Planning and Zoning Commission

July 5, 2022

TO: Planning and Zoning Commission
FROM: Evann Martin, Assistant Planner
DATE: July 5, 2022
RE: Taco Bell – Site Plan

RE: Taco Bell Site Plan

CIVIL EXISTING SITE AND DEMOLITION PLAN

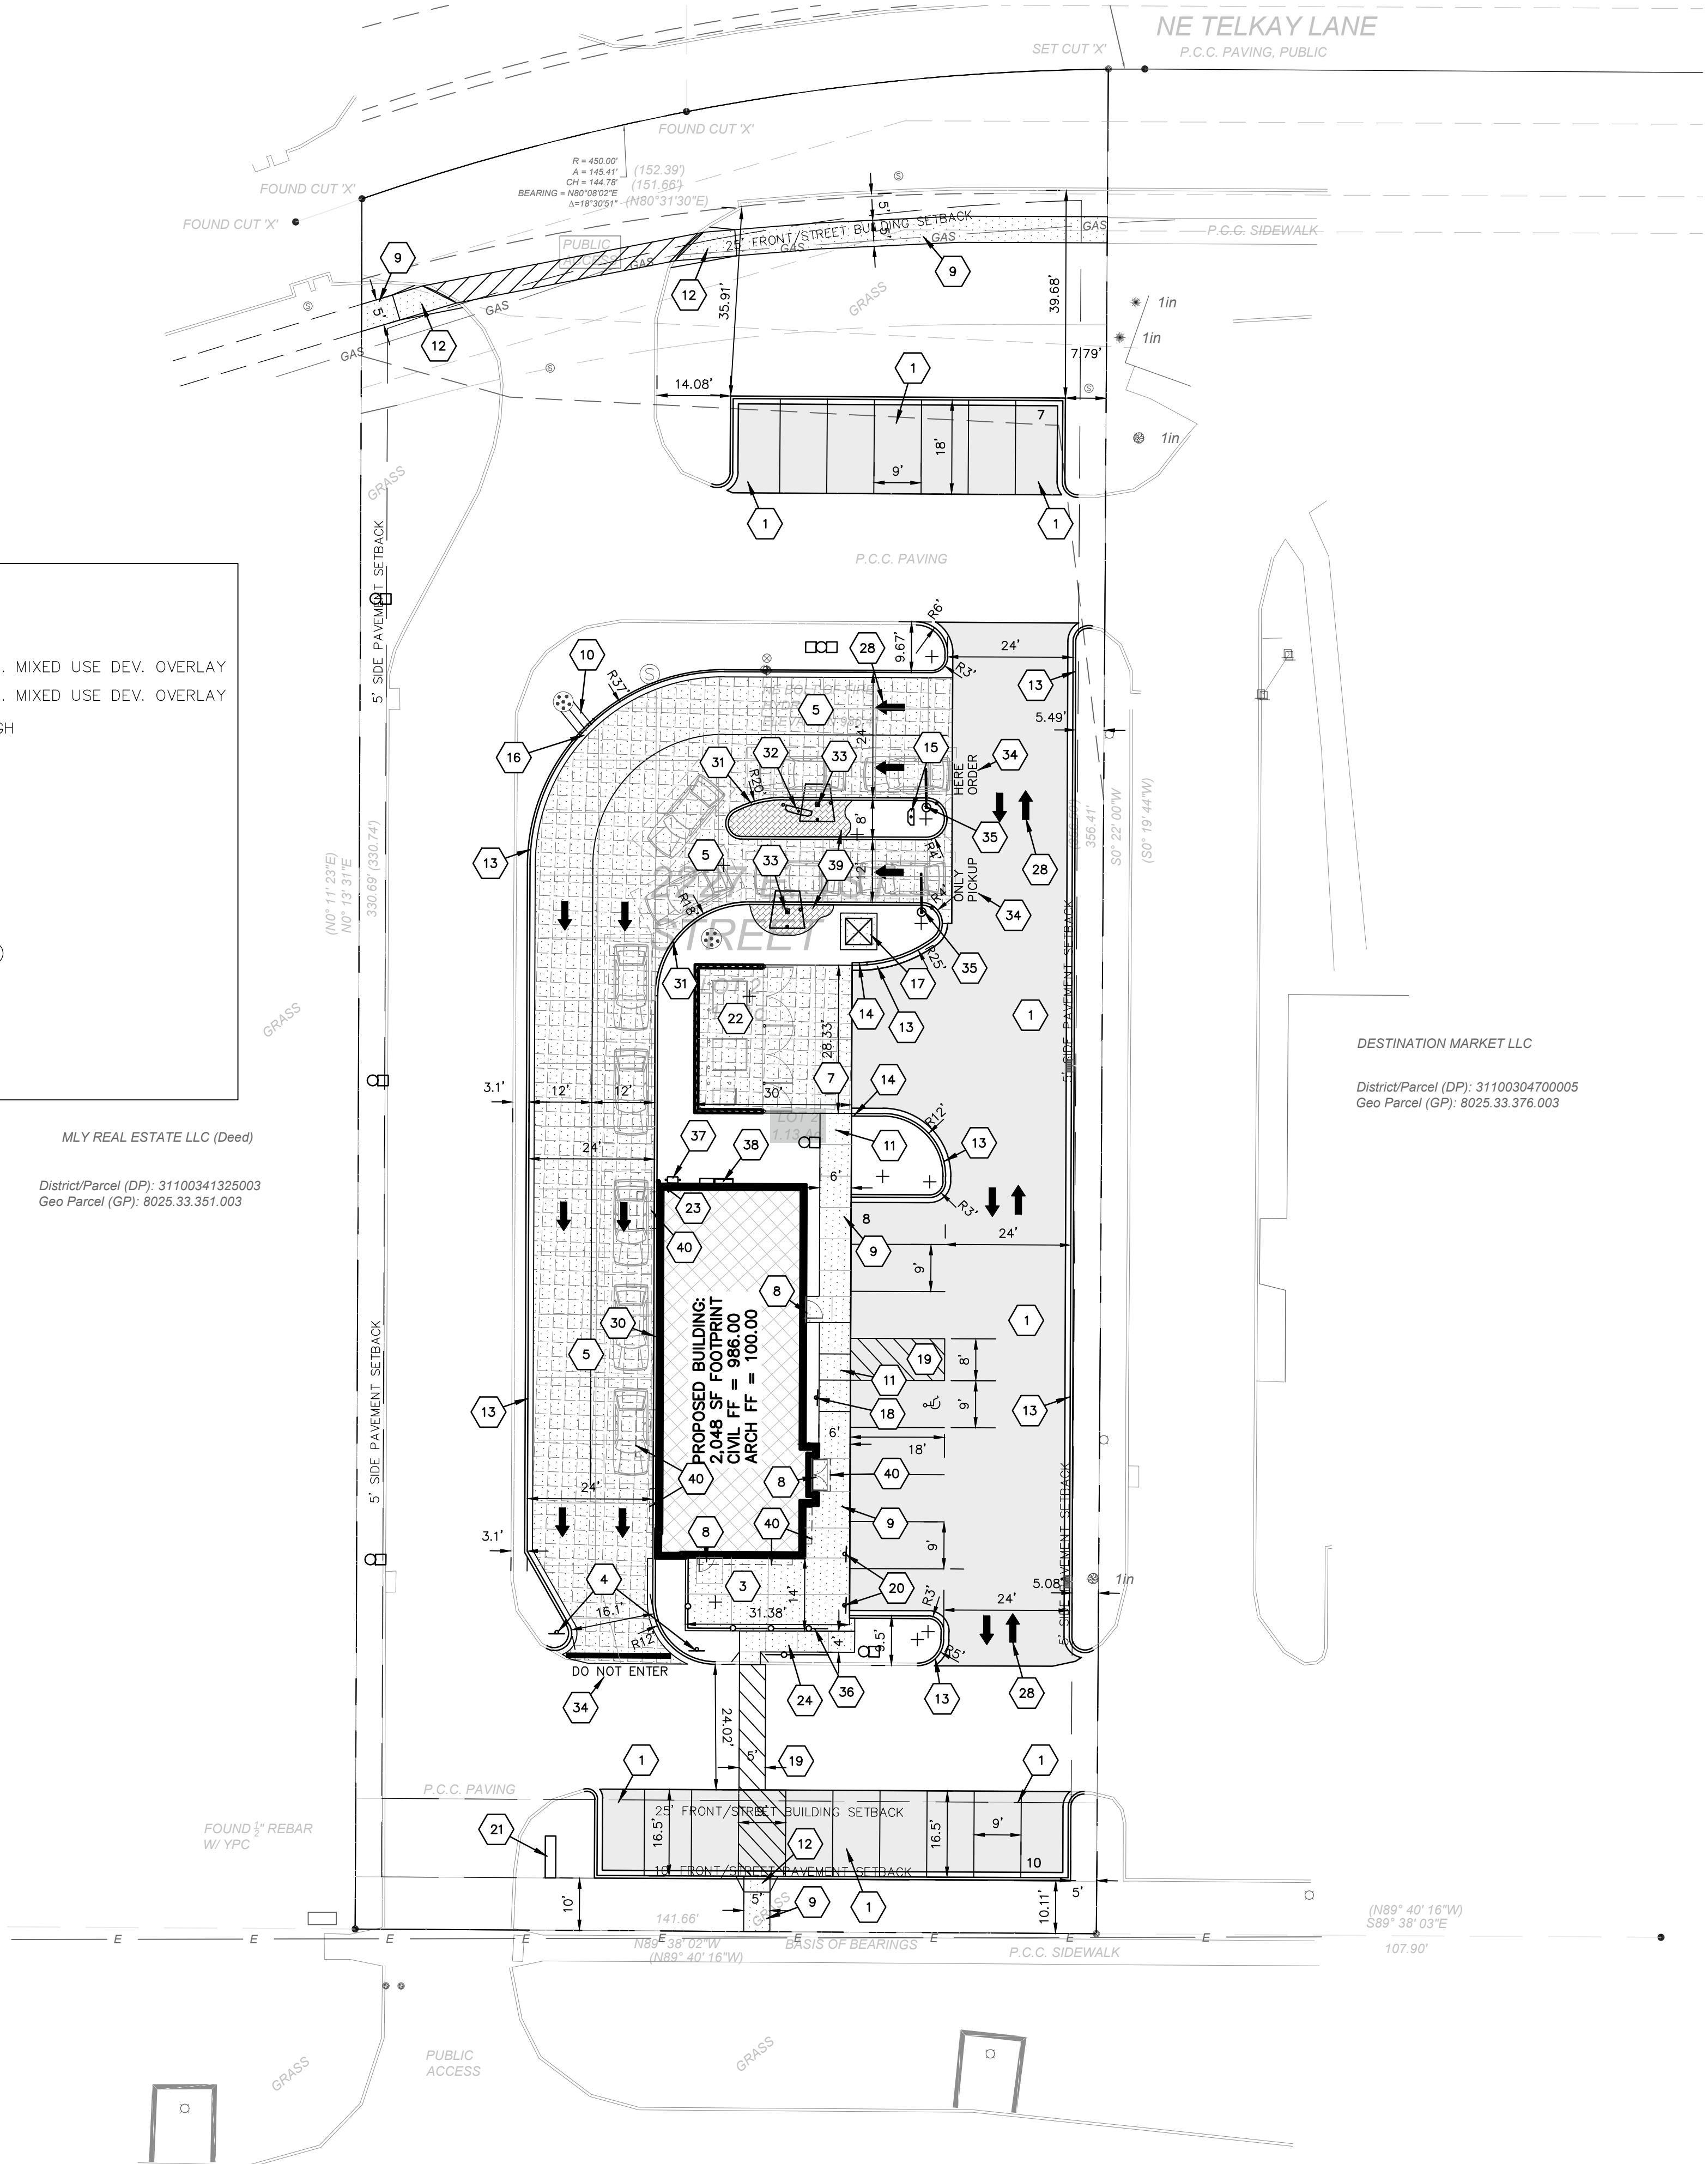
- ~~1. Revise Note C under 31000 Erosion Control. Inspections after rain events are no longer required per GP2 that came out in 2018.~~
2. Erosion Control notes A – calls out for the site being exempt from the NPDES requires. Due to this site previously being developed under a NPDES general permit number 2, this site would be required to obtain their own NPDES General Permit Number 2. Provide copy of NPDES permit and SWPPP.

C1.1

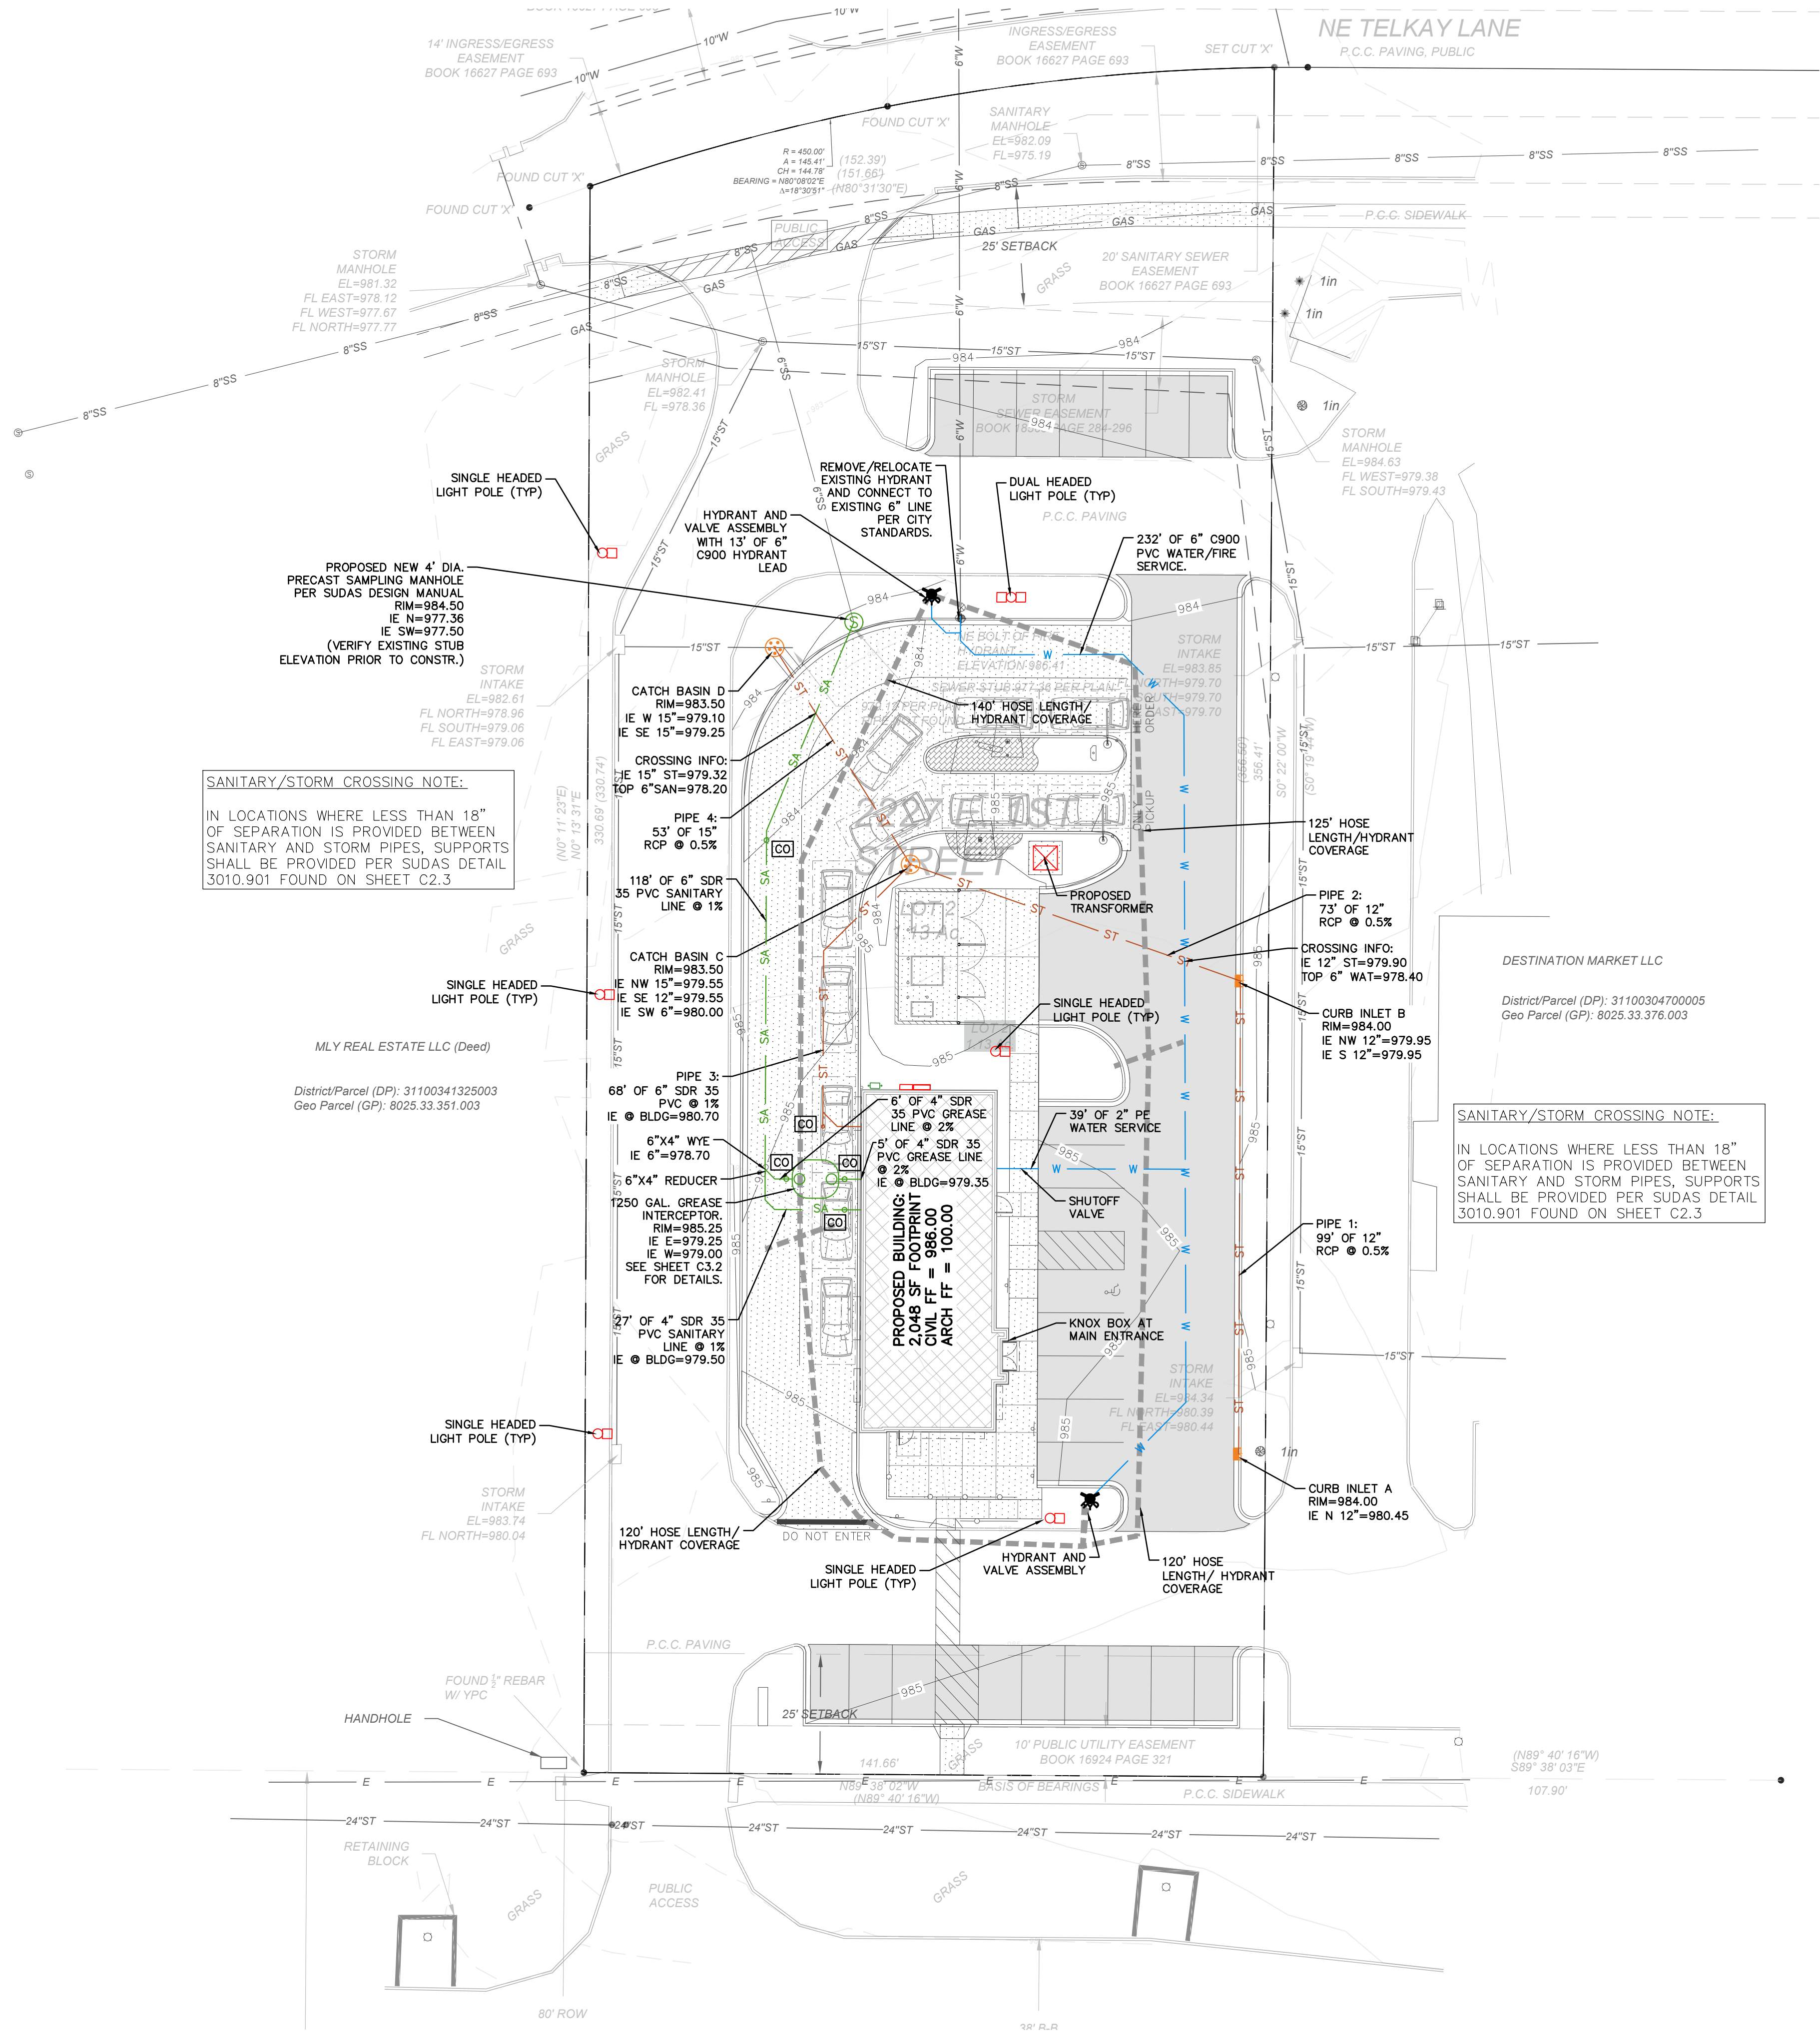
8. Staff would like to see a sidewalk connection into the site if possible. Could a connection be provided from the sidewalk along E 1st St to the sidewalk running along the east side of the building? Please provide and island instead of the pavement striping in the parking space.

EXTERIOR GREASE INTERCEPTOR

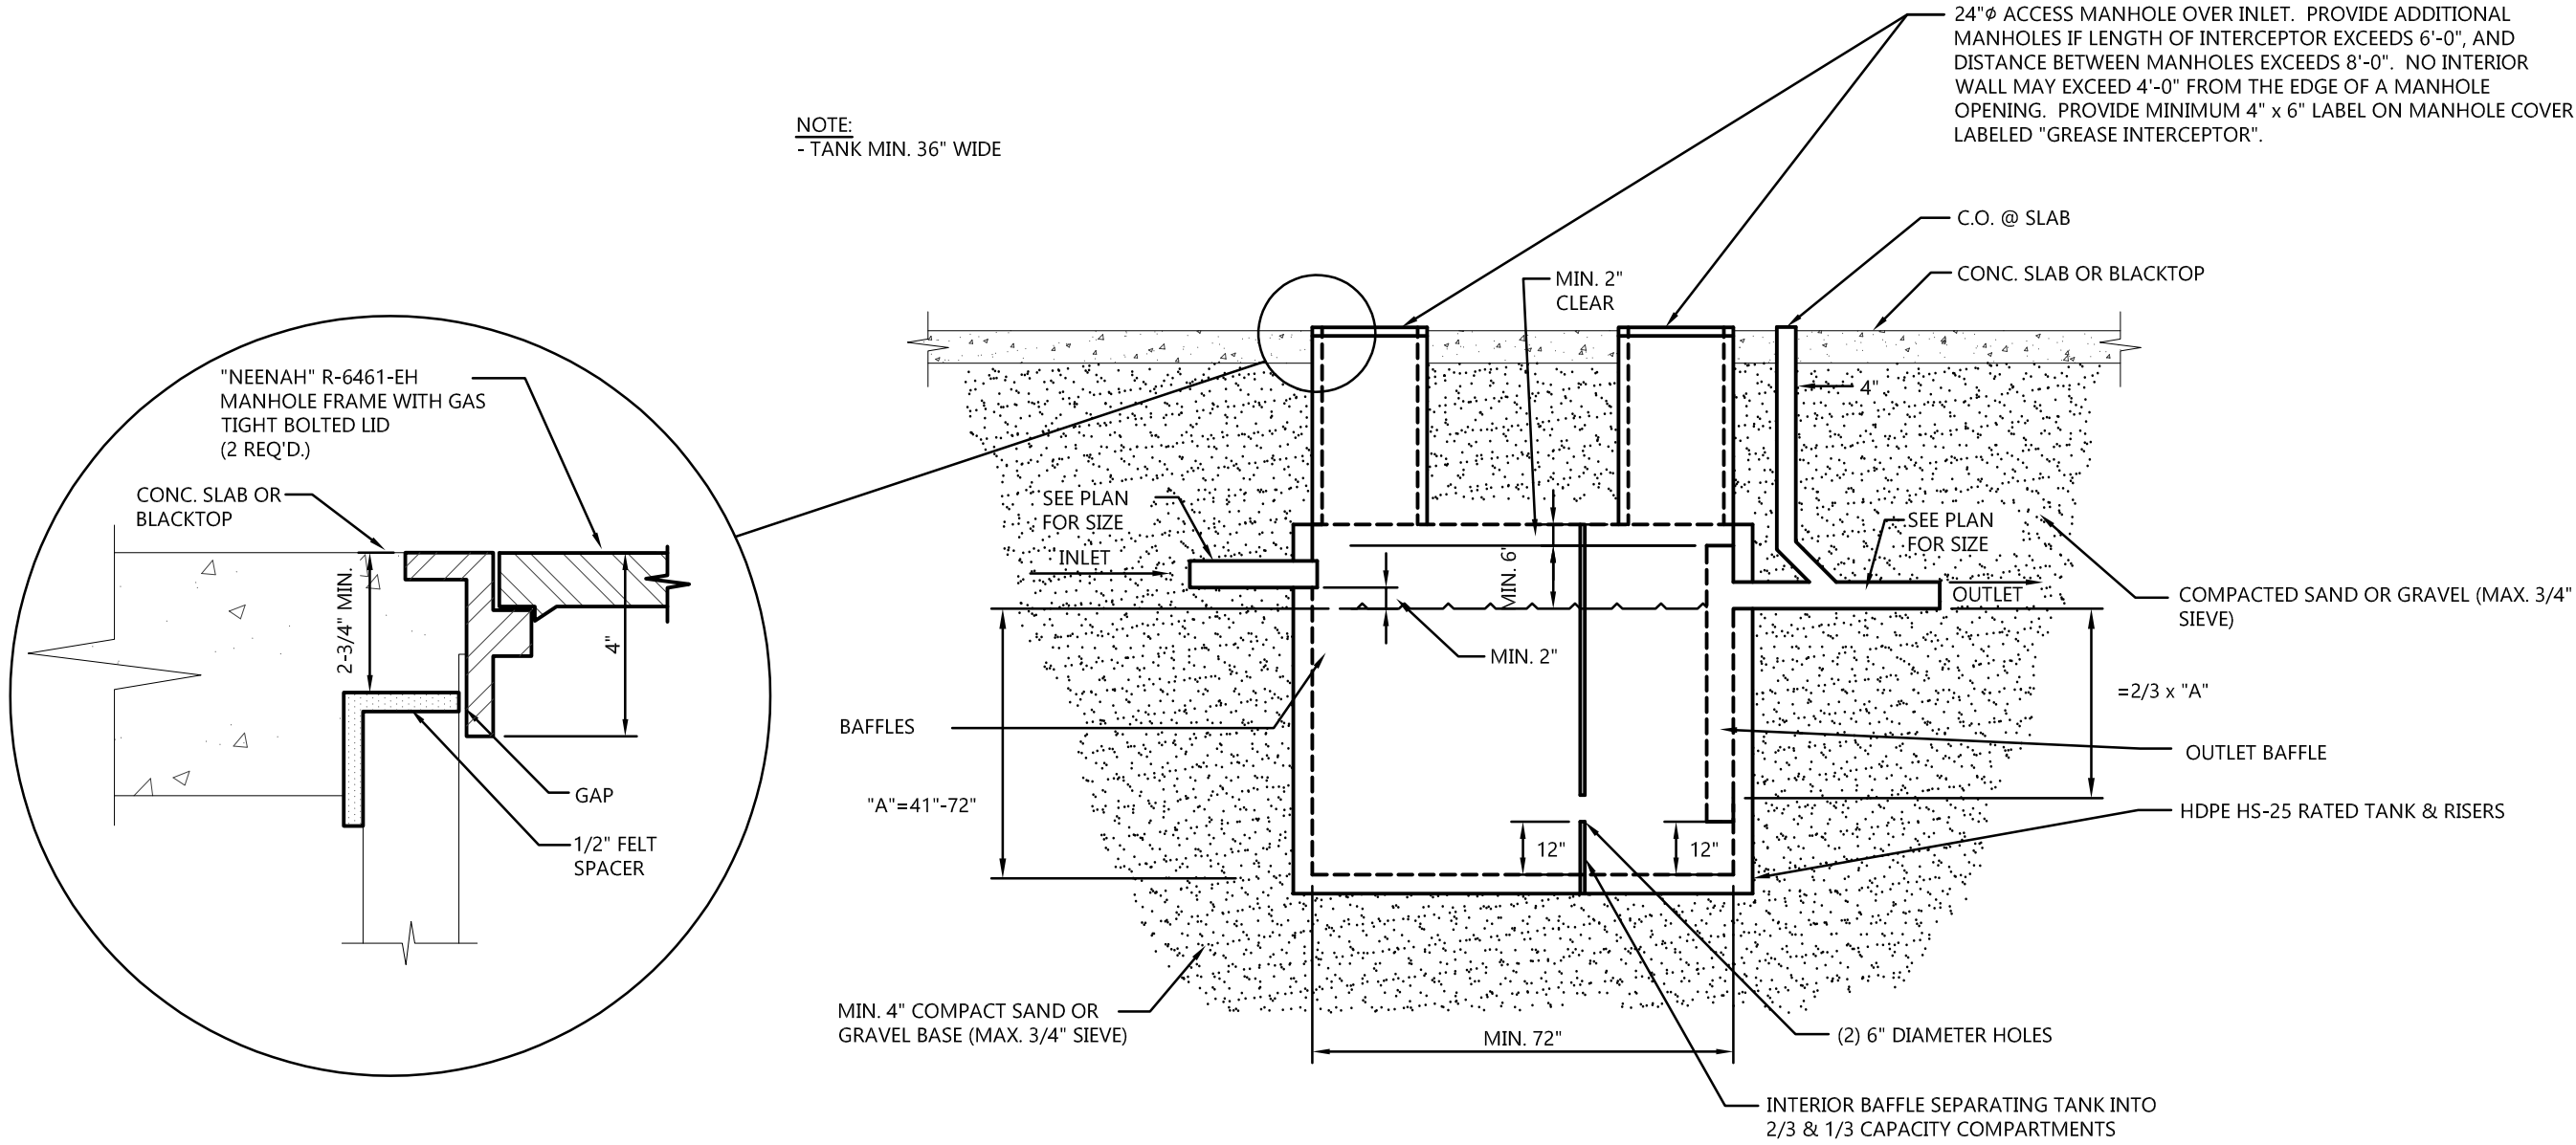
9. ~~Please identify type and size of manhole for the sanitary manhole.~~
10. The 1250 Gallon grease interceptor will need to be sized to meet the WRA standards. Please contact Jason Merk at the WRA. **It does not look like the grease interceptor has been sized per WRA standards. Please provide WRA sizing decision.**
